Service Letter

Service Bulletin No. SL TMG 000-1006, Initial Issue
Date: September 15, 2017

Subject: oil contaminated electrical contacts

Figure 1 oil contaminated plug housing

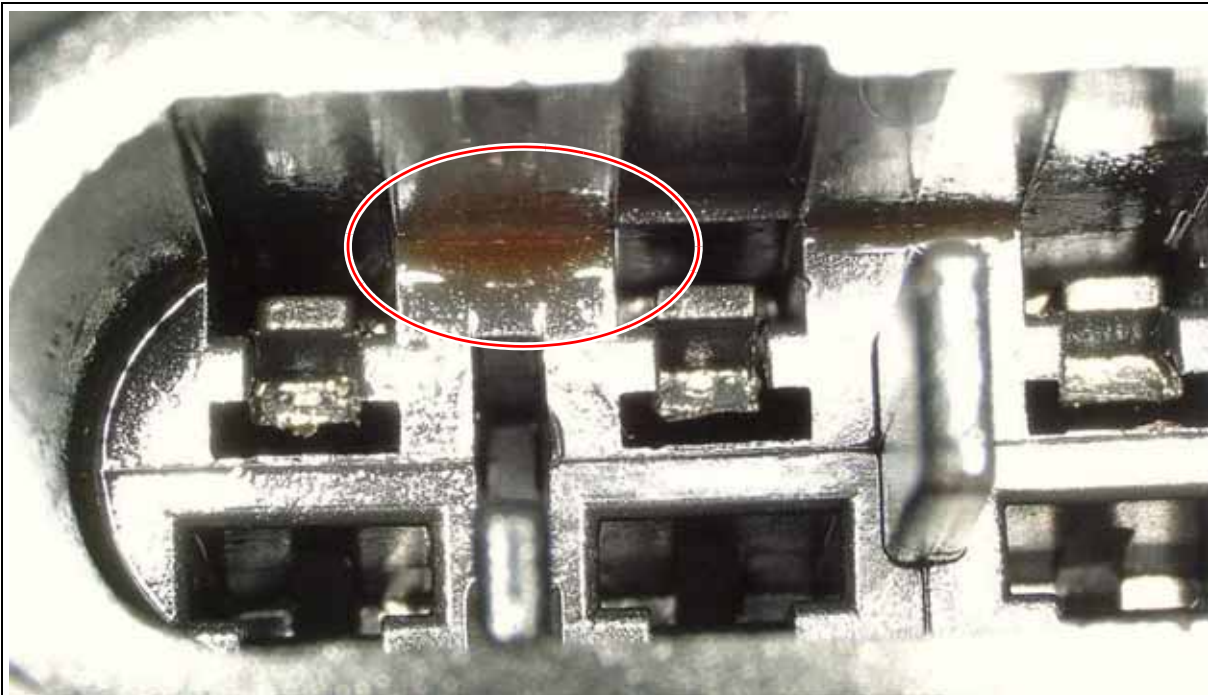
Reason: Maintenance problems were discovered due to oil contaminated contacts. This could lead to electrical contact problems and possibly to a malfunction.

- Correction:** When changing or filling oil or coolant it must be ensured that the plugs are not contaminated with oil, coolant or other fluids.
Make sure that the plugs are properly closed or protected by appropriated plugs.
If plugs get contaminated, clean the contaminated components with appropriate silicone-free cleaner for electrical equipments, e.g. Rivolta S.L.X. 500 before starting the System.
Clean the plug and the socket.
- Remarks:** -
- Parts:** -
- Approval:** The technical information contained in this document has been approved under the authority of EASA Design Organisation Approval No. EASA.21J.010.
